Product hierarchy no. *				Part no.	SBU	Type / Description	Customer part no.
SBU	PG	PUG	Type				
02	007	013	0000002303	See list below	Connectors	Appliance Outlet 16A 4797-5	-

Product Change Notification					PCN for 4797-5		
owner	creation date	release date	released by	change order no	rev	page	D10-028-631
vettessa	20.08.2018	20.09.2018	limachcl	2016092	A	1 of 2

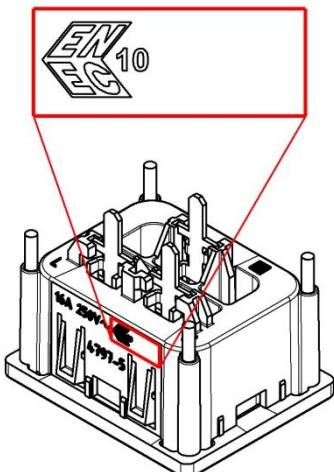
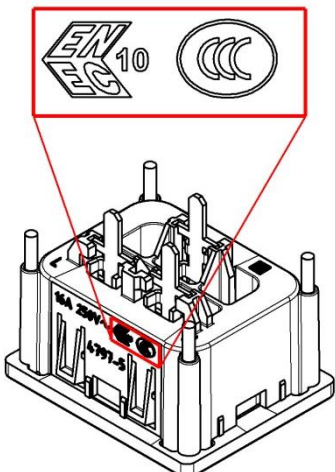
Old material	New material
Polyamid PA6/66	Polyamid PA6
Old appearance	New appearance
